Product Change Notice (PCN)

PCN Number: PCN-0451188R-01

Product(s) Affected: PJ-051A, PJ-051B, PJ-051AH, PJ-051BH

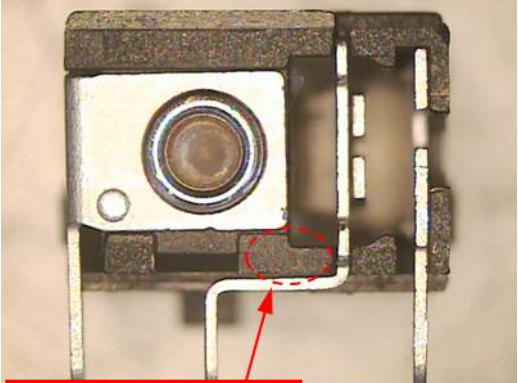
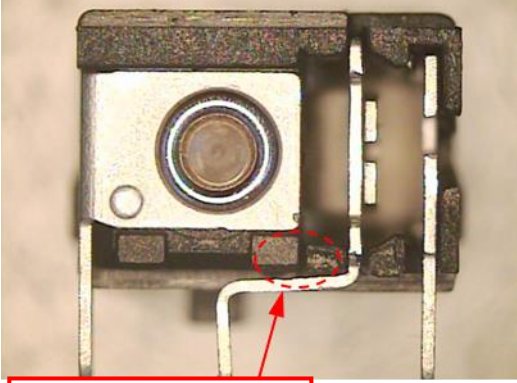
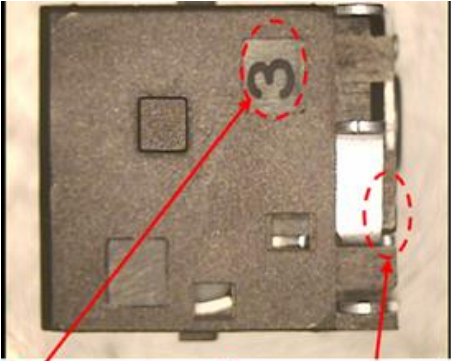
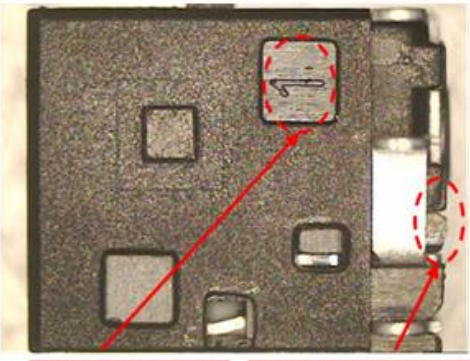
Reason(s) for Change: The existing molds of PJ-051A, PJ-051B, PJ-051AH, and PJ-051BH are unable to maintain efficient production. To ensure the quality and lead-time of production, a re-development of the mold has been processed. We have taken this opportunity to also optimize the product design to enhance the quality. The new mold will optimize the design, enhance the appearance, the electrical structure while function will remain the same (The comparison photos are available below).

New version	Current version
Back	 <p data-bbox="300 831 596 904">Without gap</p>	 <p data-bbox="933 831 1241 904">With gap</p>
Bottom	 <p data-bbox="327 1402 555 1453">Smaller mark</p> <p data-bbox="555 1402 772 1453">Without gap</p>	 <p data-bbox="981 1402 1182 1453">Bigger mark</p> <p data-bbox="1182 1402 1428 1453">With gap</p>
